# ISW-168XX PoE Switch Software Release Notes

FW Release Version: v01.01.04.0002 (for all models)

Documentation Date: 2024/01/05

WEB: Serial number display at page of Monitor/System/Information

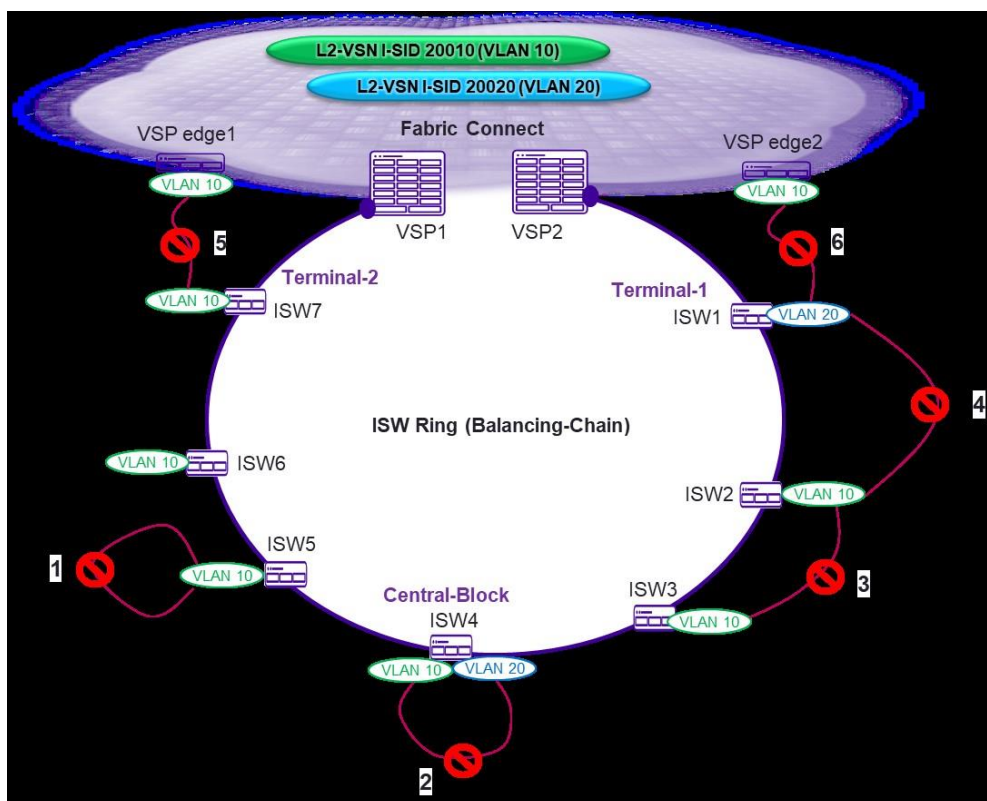
1. CLI/WEB/MIB implementation to report the Serial No. of the ISW switch.

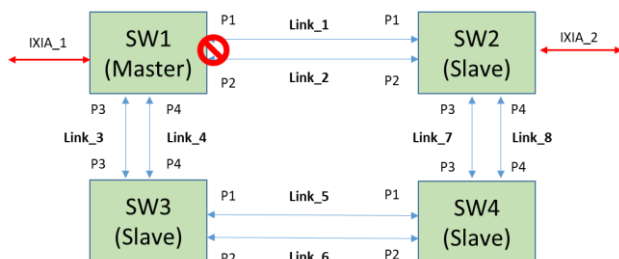
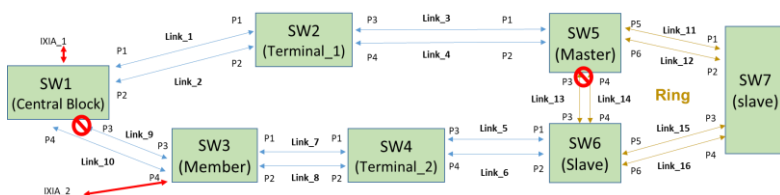
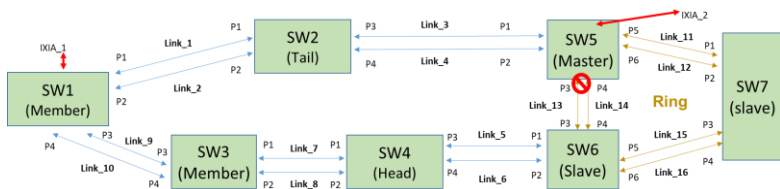
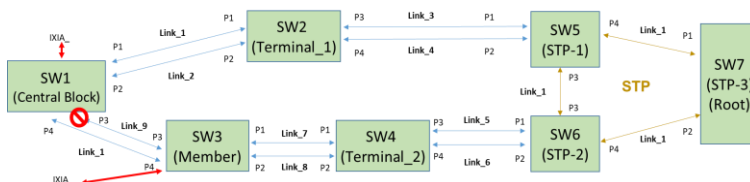
1. Support Dual Ring (Ring/Chain with LAG)
  - Support this feature in all of Ring/Chain/Coupling/Dual-homing/Balancing Chain technologies).
- Restrictions of Dual Ring
  - Each LAG Ring node only support 2 ports of LAG
  - Don't make Ring topologies mixed with STP when enable LAG Ring nodes. (Recovery time is bad)
  - Not support LACP (Only support Static LAG)

- Supported topologies:  
Average recovery time are same as original Ring technologies (Almost same as without LAG). The recovery time is less than 50ms.

- Supported topologies but not support to use due to bad recovery time.

### State chart of 802.1X/MAC auto sense mode

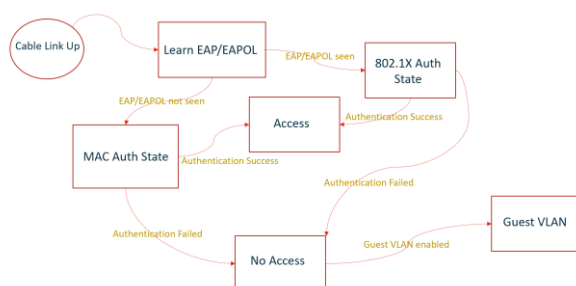
2. Support “Enable both MAC and 802.1X auth on same port”  
→802.1X/MAC Auth auto sense mode.

- Mode States
  - Try to authenticate through 802.1X else
  - Try to authenticate through MAC else
  - Provide Guest VLAN access (if Guest VLAN is enabled) else
  - No Access

- New timer parameter: Sense Period  
Used to identify if the client enabled 802.1X. Identification method is to learning if the port received EAP/EAPOL packets, the first learnt packet will be EAPOL start normally after port is linked up.
  - CLI:  
(config)#dot1x timeout sense-period <10-255>, default: 10 seconds
- New mode of port control: dot1x port-control sense  
To support enable both MAC and 802.1X auth on same port.
  - CLI:  
(config-if)# dot1x port-control sense

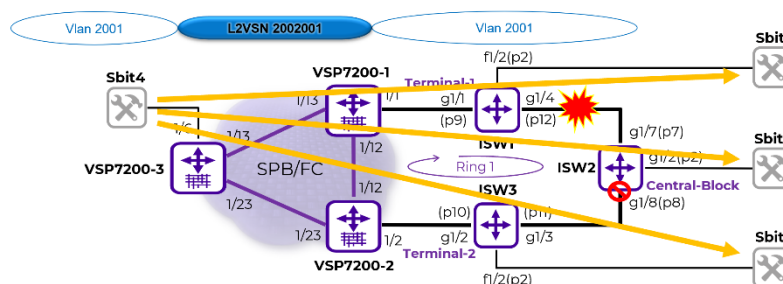
- TCN (topology change notification) of MSTP.  
ISW Ringv2(Chain/Balancing Chain) support MSTP/RSTP TCN BPDU for fast (less than 100ms) network redundancy recovery time.

Verified: ISW of TCN BDUs for fast aging of MACs on Fabric Core whenever ISW ring is cut or restored. (Less than 100ms)
